Project Name: 702 NE 3rd Avenue (2020-023)

Request: Certificate of Appropriateness, Class V Site Plan, Landscape Plan, & Elevations

HISTORIC PRESERVATION BOARD STAFF REPORT

Meeting	File No.	Application Type
January 15, 2020	2020-023	Class V Site Plan & Certificate of Appropriateness

NO	DATE	REVISION
SHEET TITLE		
BUILDING ELEVATIONS		
PROJECT		
QC EAST HOLDINGS LLC 702 NW 3RD AVENUE DELRAY BEACH, FLORIDA		
GENTRY ENGINEERING & LAND SURVEYING, INC.		
PO BOX 83-2101 DELRAY BEACH, FLORIDA 33483 (561) 302 9983		
DATE:	PE 53844 EB 2322	SHT 2 OF 7

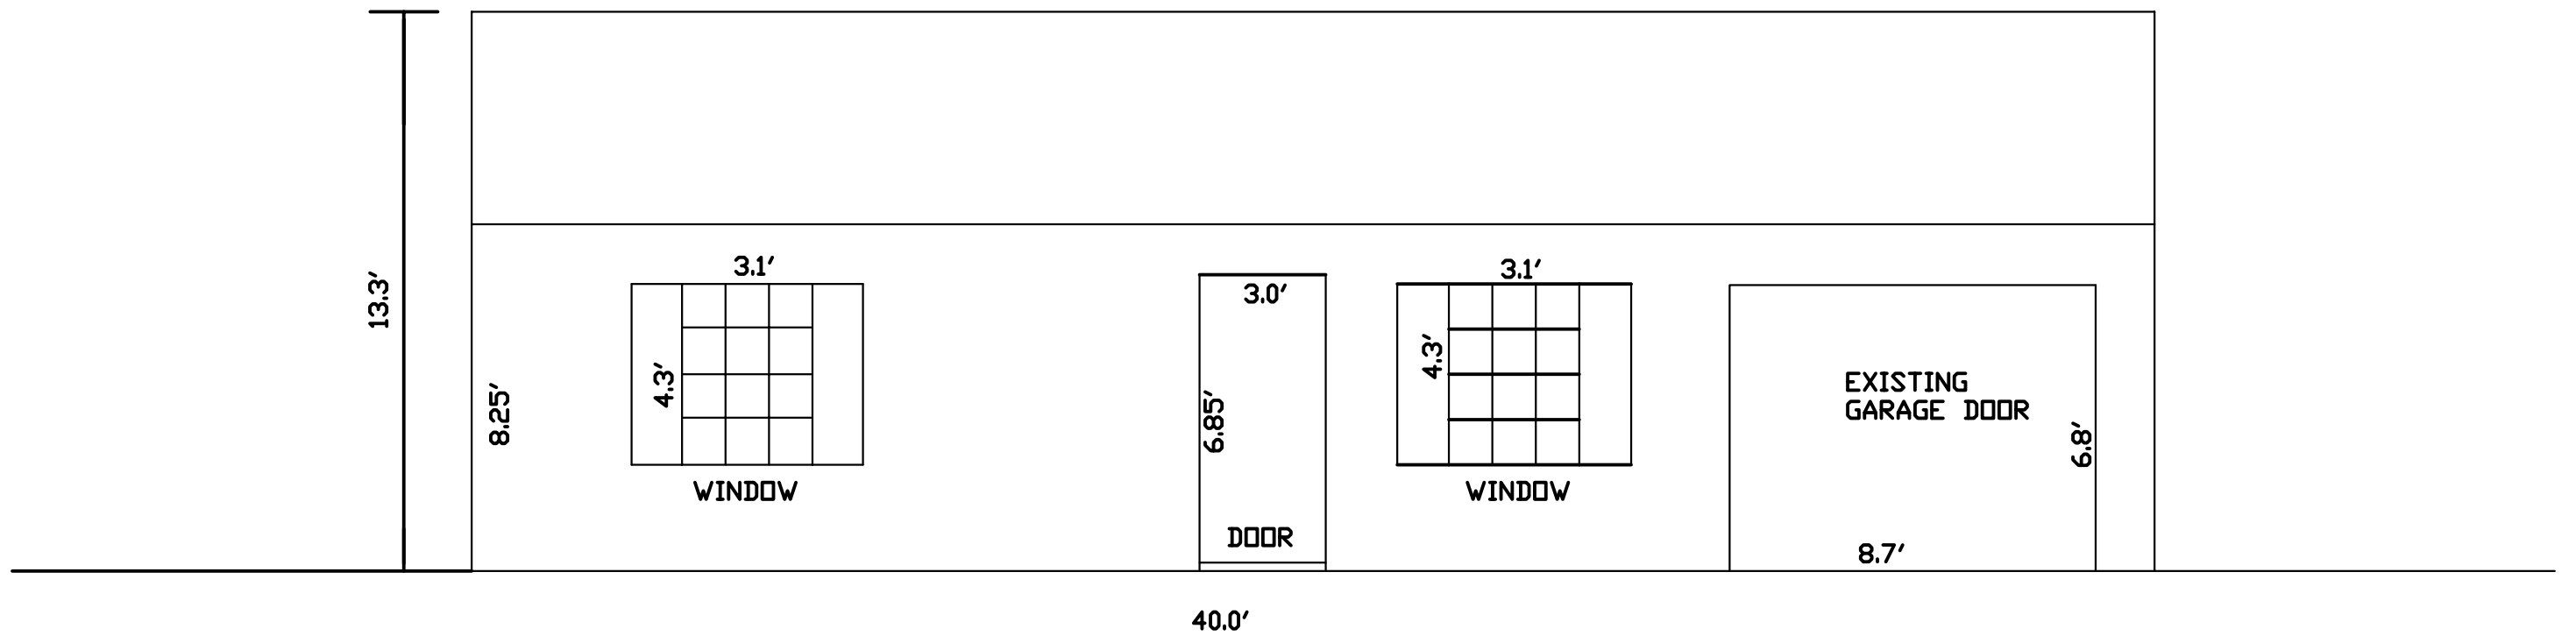
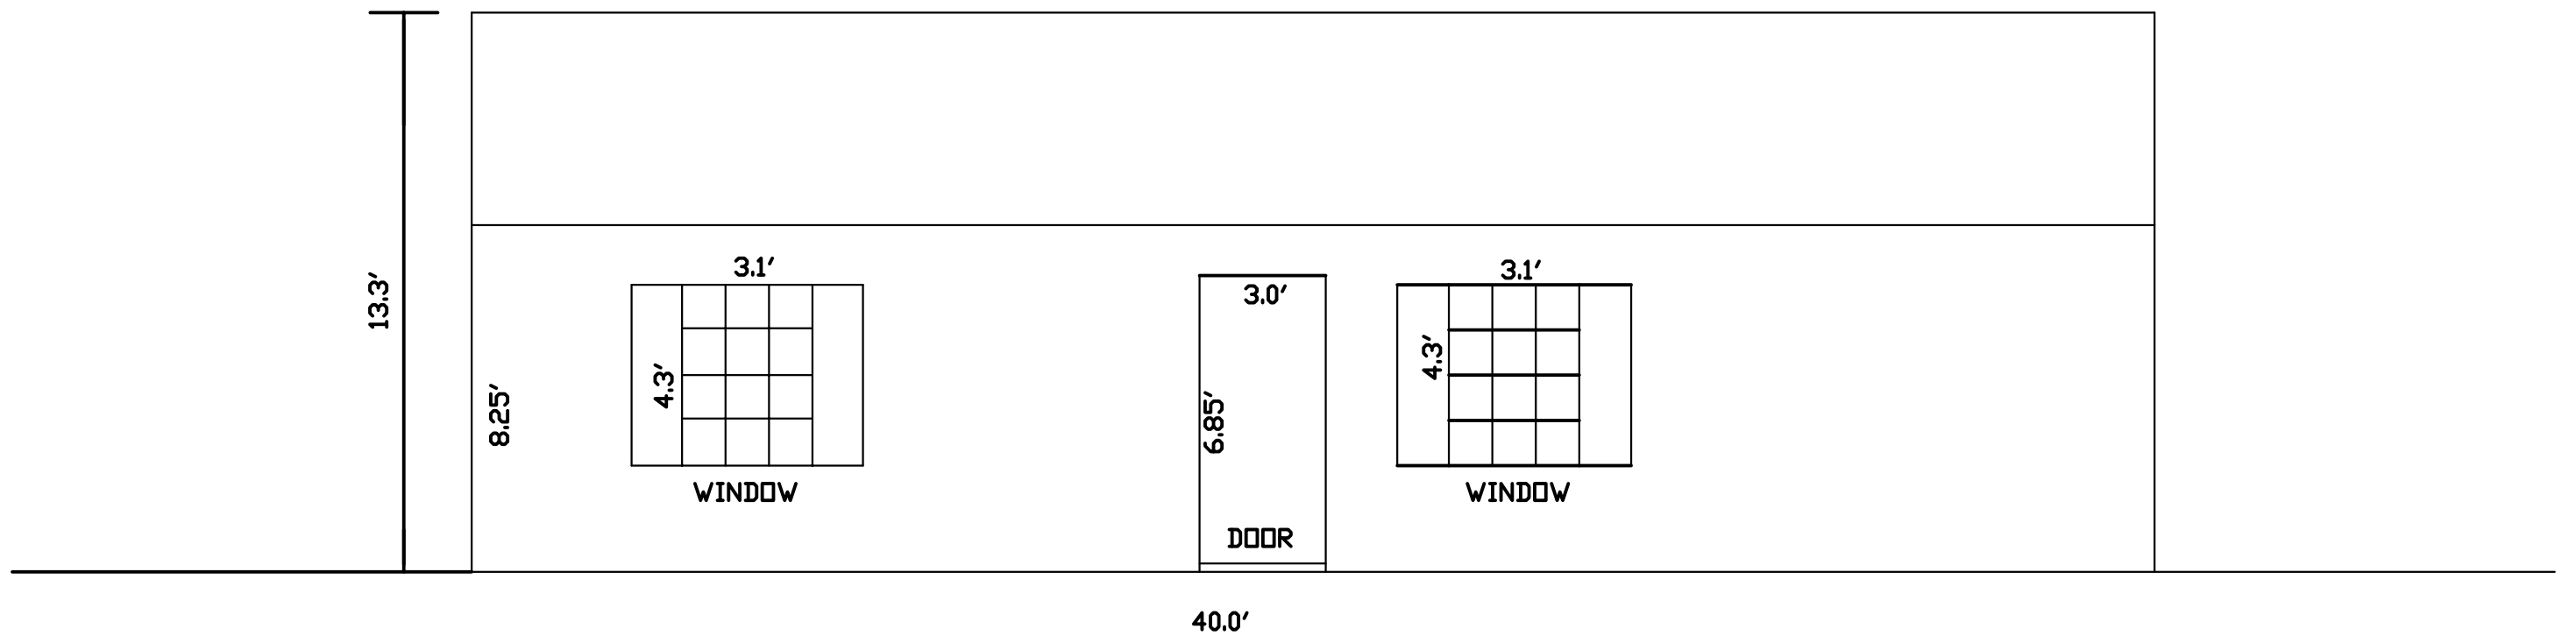
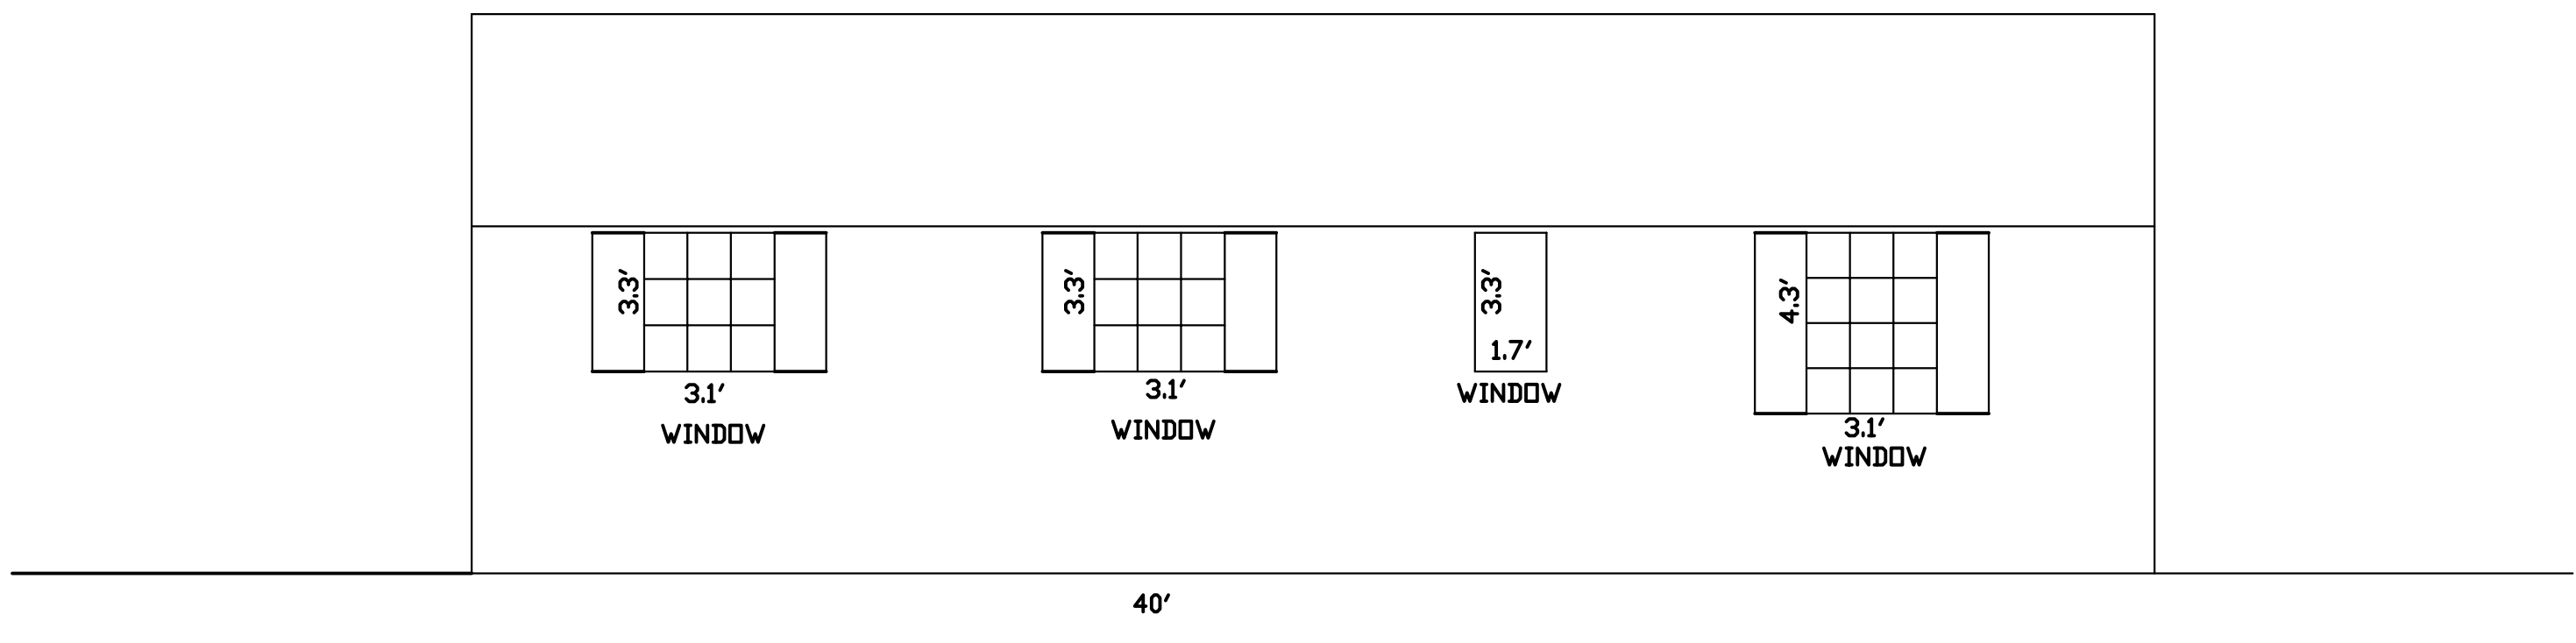
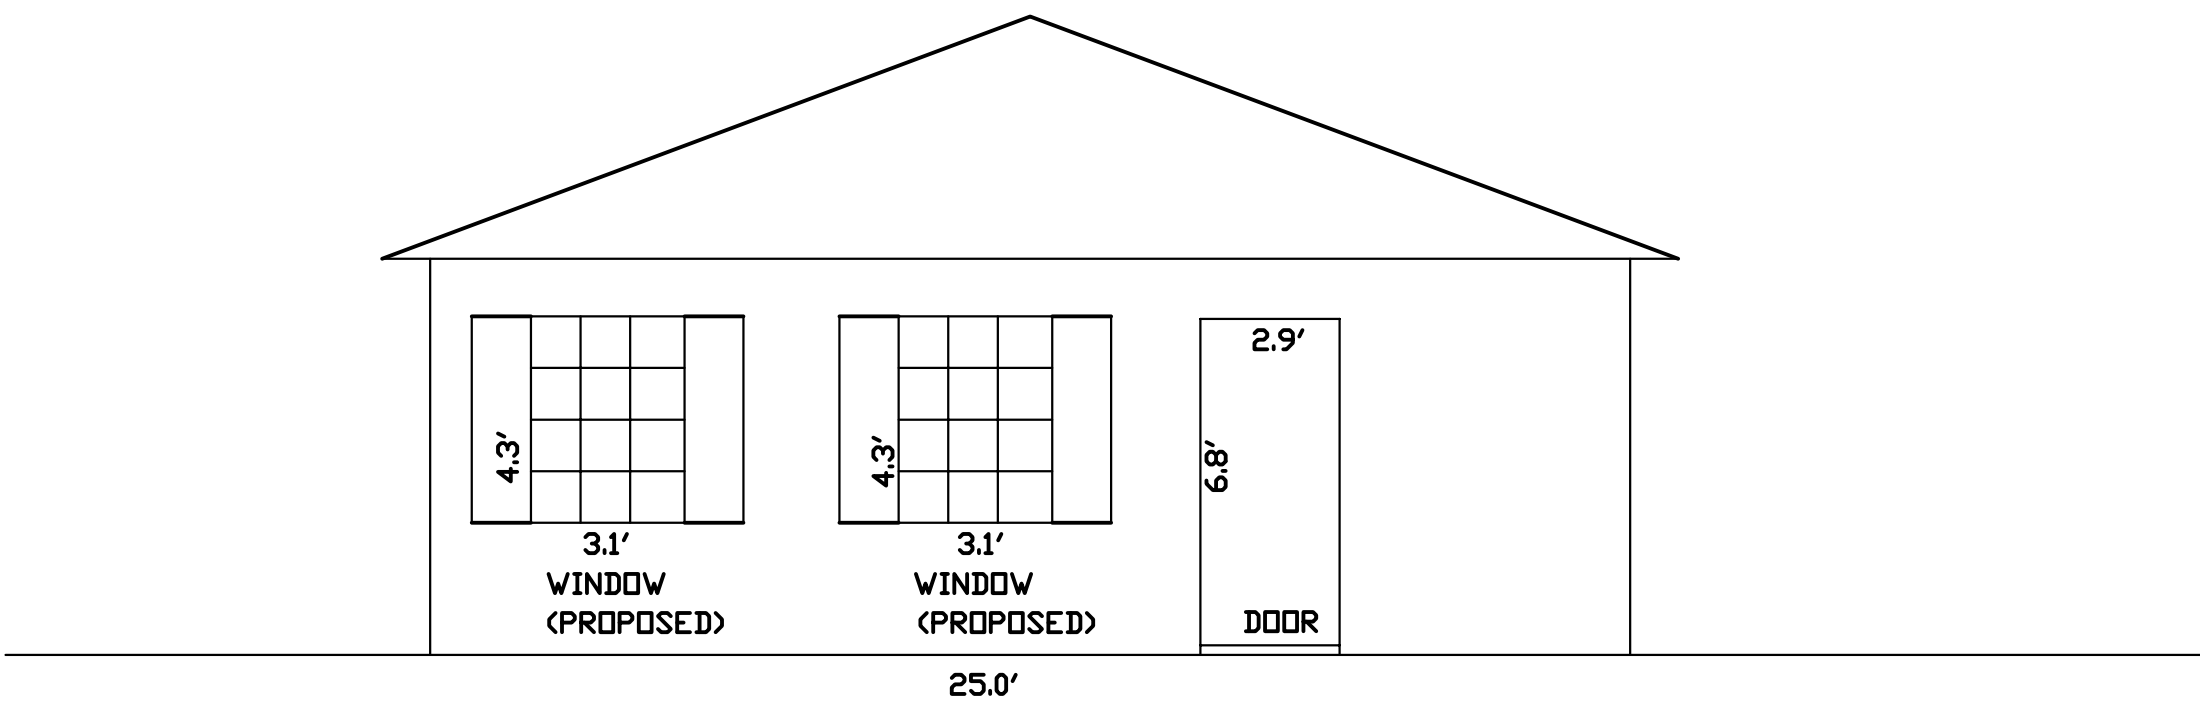
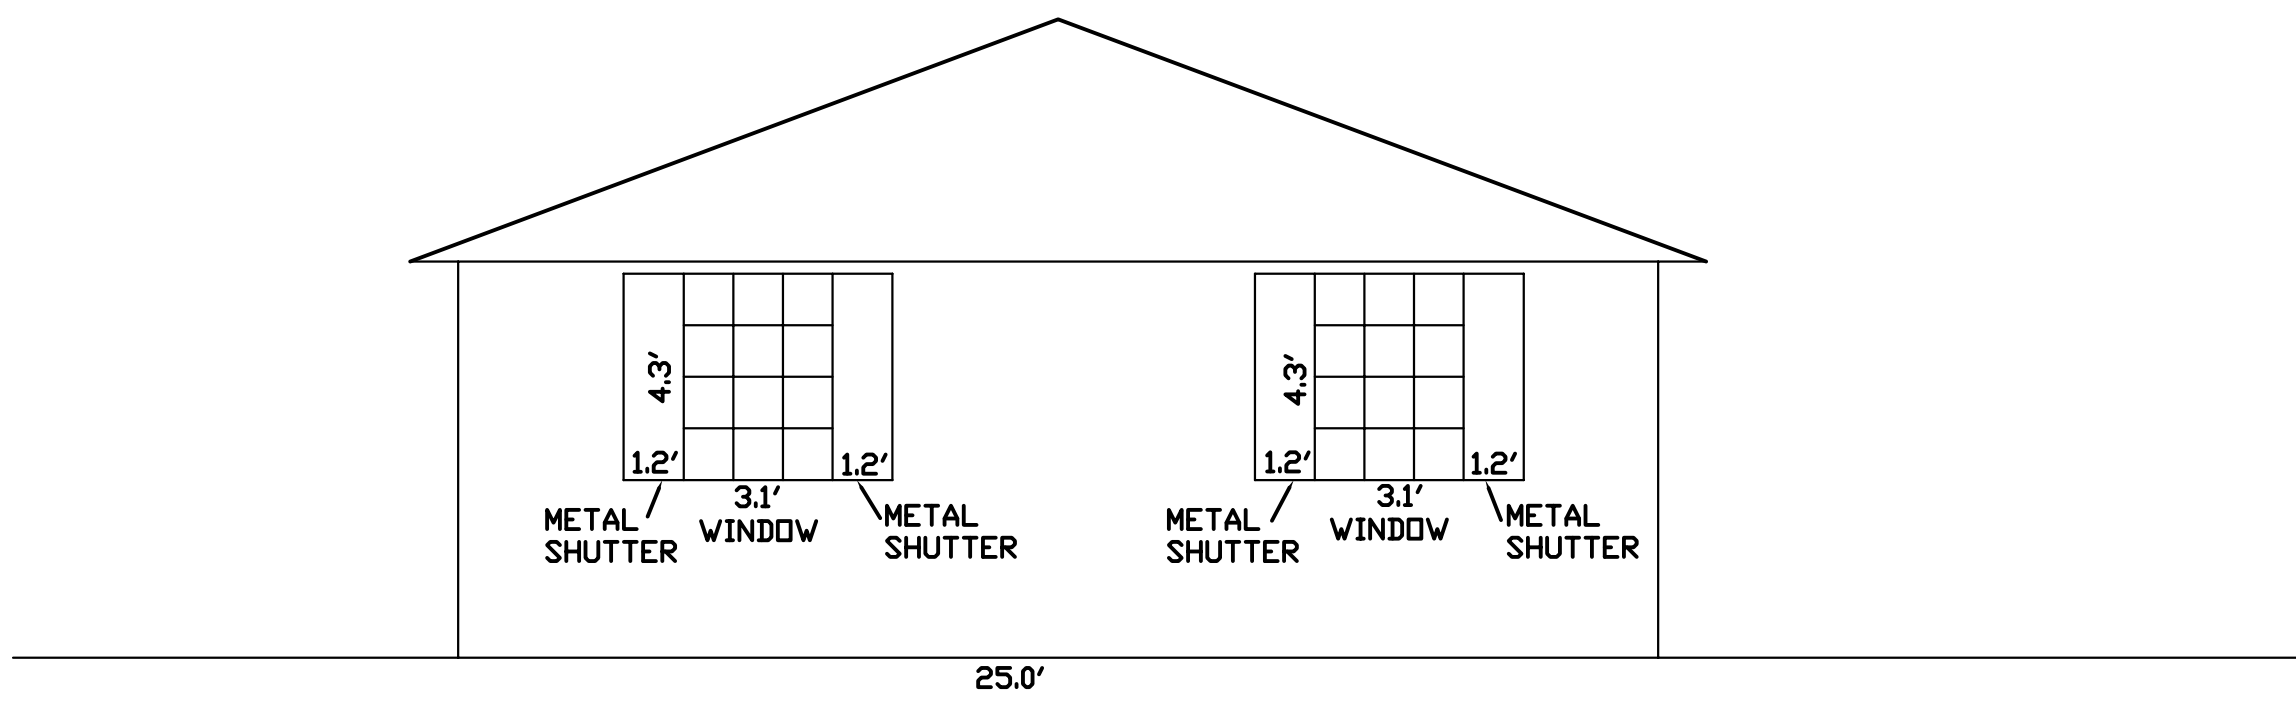
- That the existing and proposed open space and lot coverage calculations (square footage and percentages) are provided on the site plan;
- Provide existing and proposed elevations for all sides of the building including details of all proposed window openings (south elevation currently needs to show new proposed window #8);
- Include measurements of all existing windows on existing elevations; and,
- Revise window schedule to ensure measurements match elevations.

A site plan technical item is included that existing elevations be provided for all sides of the building and that dimensions for all windows be provided on the elevation drawings.
